October 17, 2016

As a follow-up to my letter dated September 2, 2016, I am sharing with you a detailed FAQ document that we have prepared in response to the various agency and stakeholder questions received by the City of Toronto during the review process of the planned Ground Run-Up Enclosure (GRE) at Billy Bishop Toronto City Airport.

**Planned Ground Run-Up Enclosure (GRE) Follow-up Questions  
October 17, 2016**

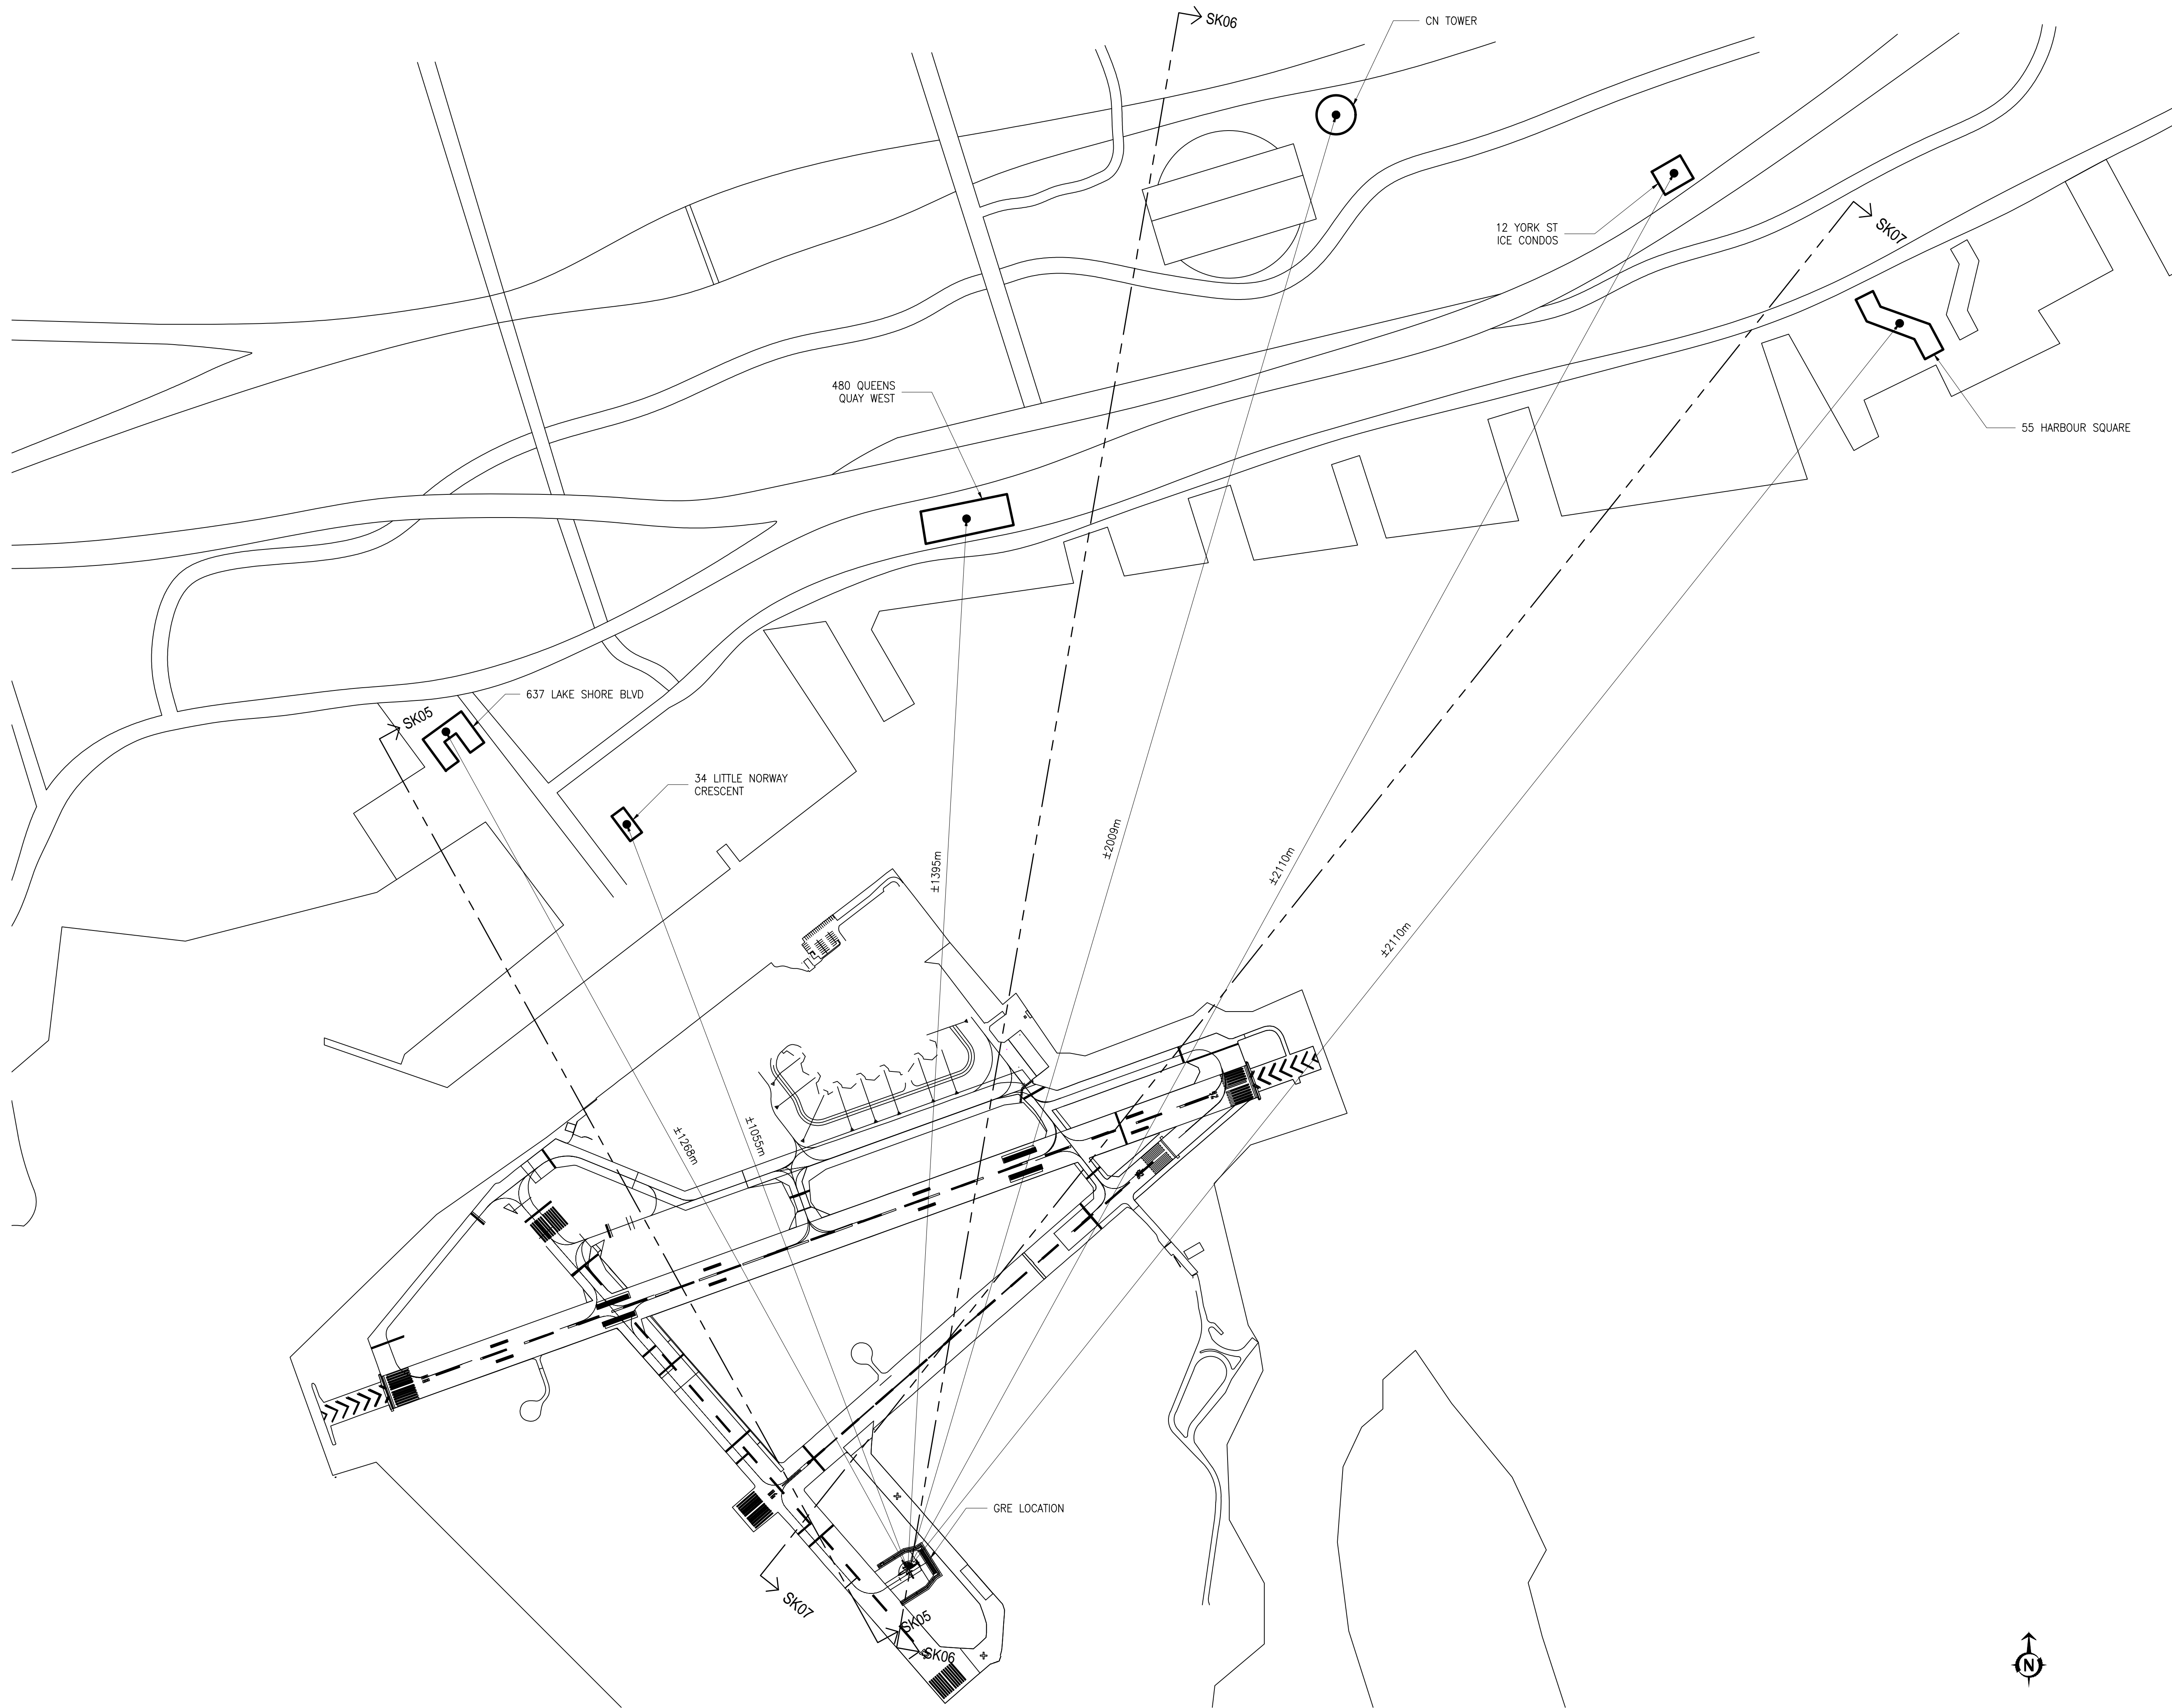
**Q17. Elaborate on the various types of run-up procedures performed at Billy Bishop Airport, including the average frequency of each procedure, and a map identifying the location of each. Please confirm which run-up procedures are technically capable/incapable of relocation to the GRE.**

All engine power runs (high power) are currently conducted during the airfield rehabilitation work at the "PRIMARY" location on the below map.

- 1) Low power engine idle runs are completed at the gate and do not need to be performed at the GRE; and,
- 2) Power runs (high power) will all be conducted at the GRE when constructed.

It is difficult to determine the exact frequency, as it depends on when and what type of maintenance procedure is done. In 2015, there were 358 engine runs which averages out to 1 engine run per day.

In terms of what procedures are possible in the GRE, aircraft engine run-ups/high power runs can be performed in the GRE based on suitable wind conditions.

SHEET TITLE:  
AREA SITE PLAN  
WITH DISTANCES

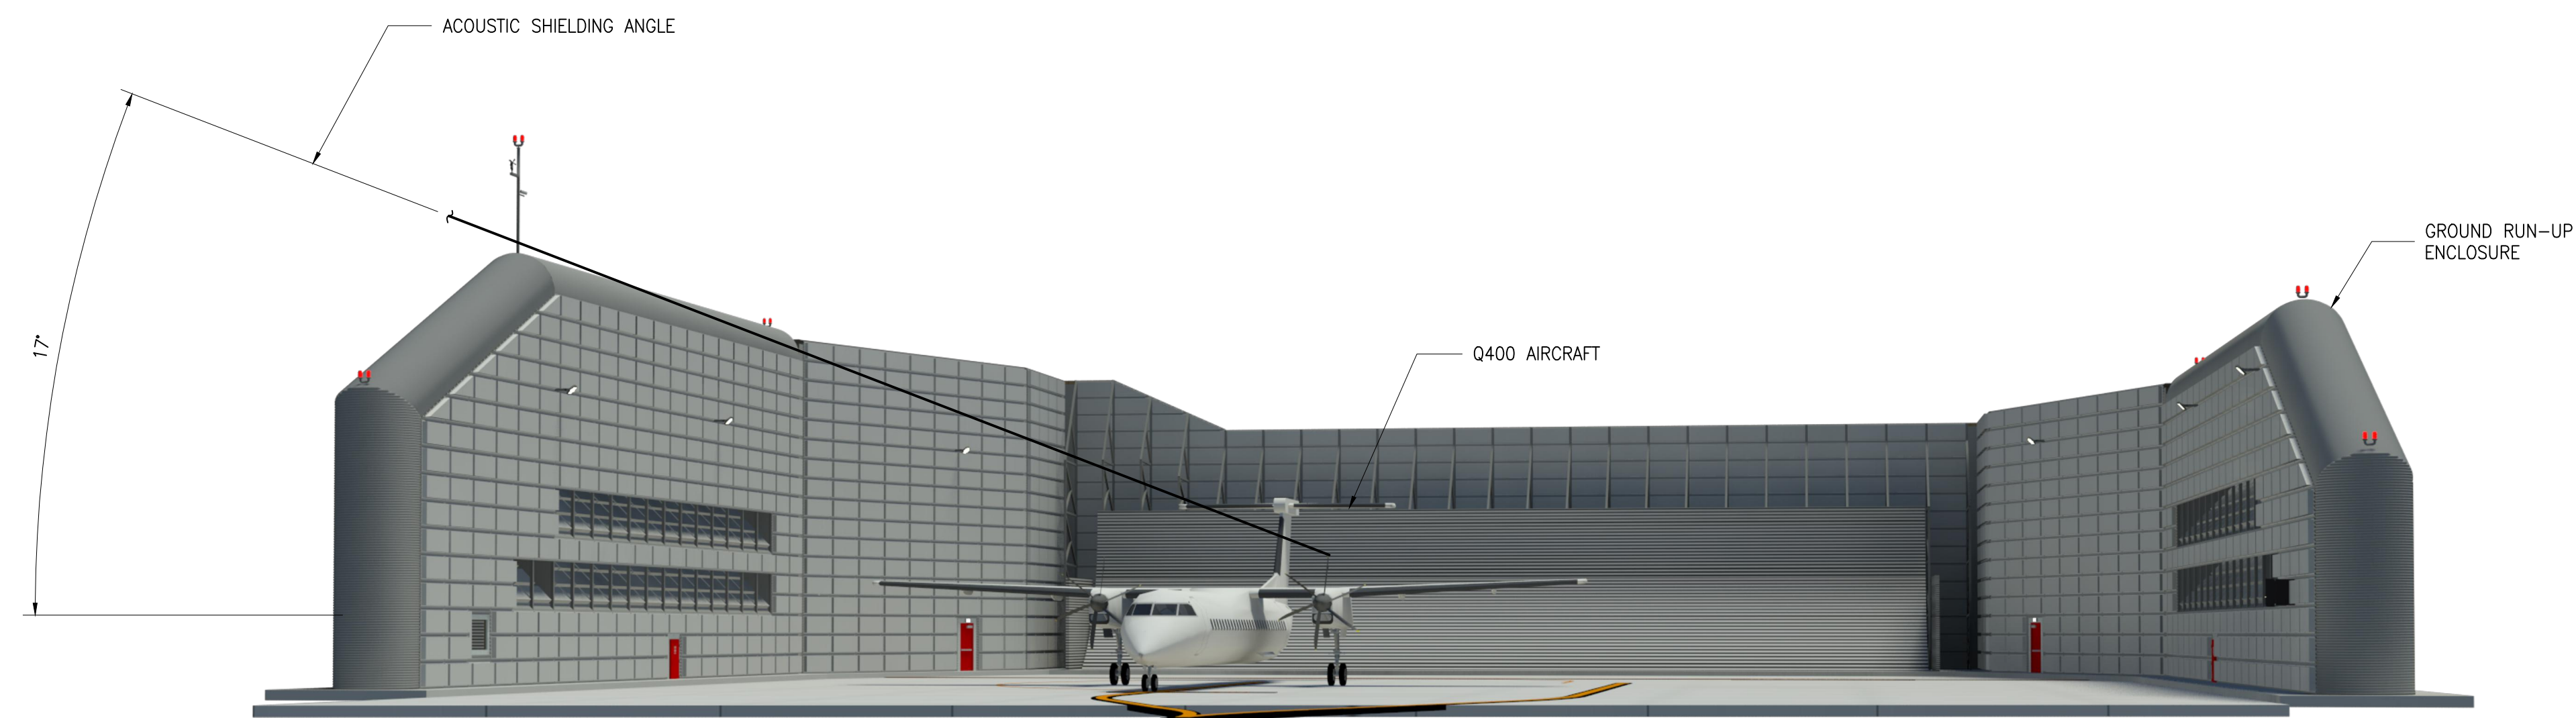
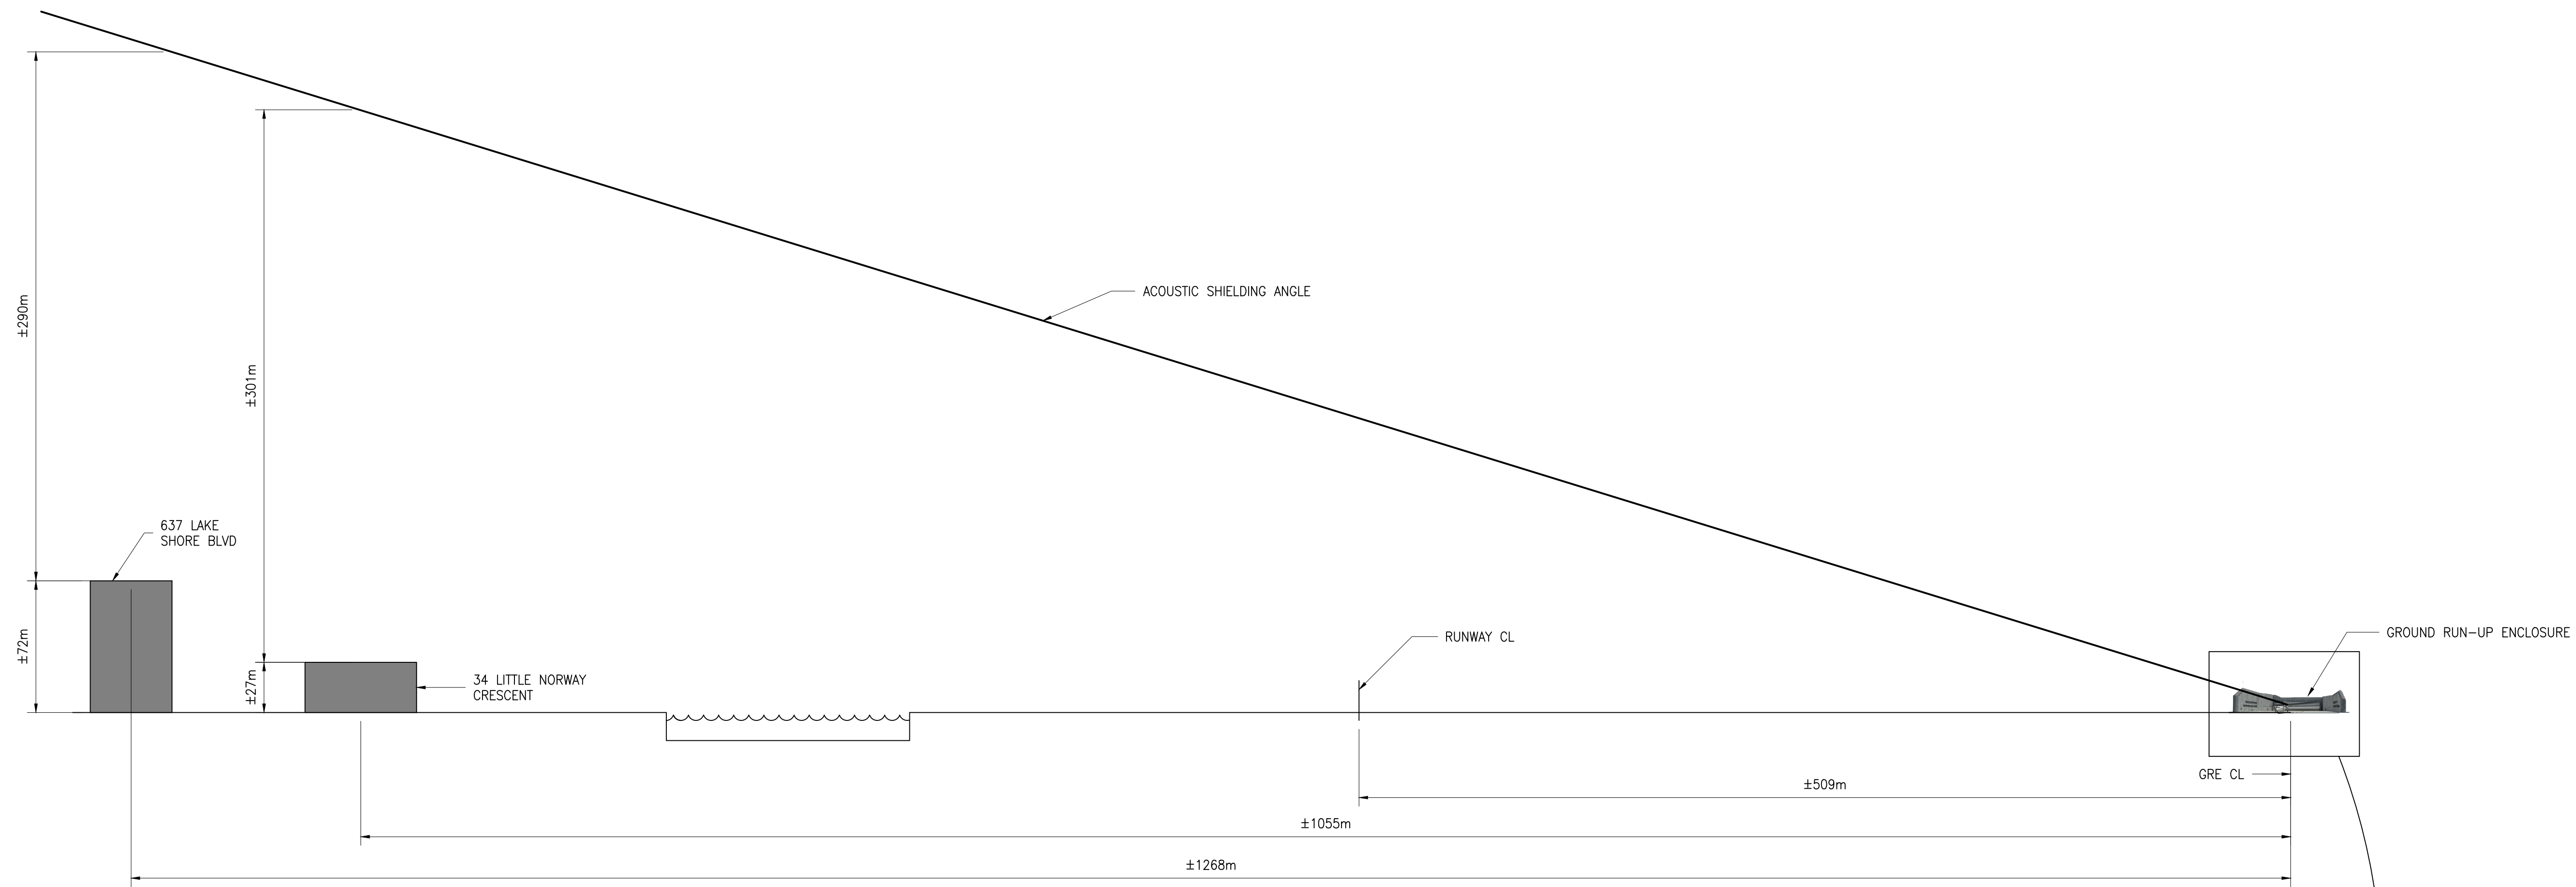
**Q7. Elaborate on the relationship of elevation to GRE noise abatement. At what elevation does the noise abatement begin to diminish? At what elevation is the abatement no longer effective? Confirm there is no elevation or location at which the GRE creates a net increase in current noise impact from run-up procedures.**

The benefit of any GRE varies depending on one's elevation, with the optimal noise reduction at ground level. The only noise receivers to receive zero benefit from a GRE facility would be those with a direct line of sight into the facility. In this instance, noise receivers along the Toronto waterfront below an elevation of approximately 600m will benefit from the GRE due to a reduced, or eliminated, line of sight into the facility. Currently there are no buildings along the waterfront or downtown area that will not benefit from the noise abatement provided by the GRE facility. BDI has created cross-sections, which include land mark buildings on the waterfront to illustrate that there are no buildings which penetrate the line of sight (see attached Line-of-Sight Sketches).
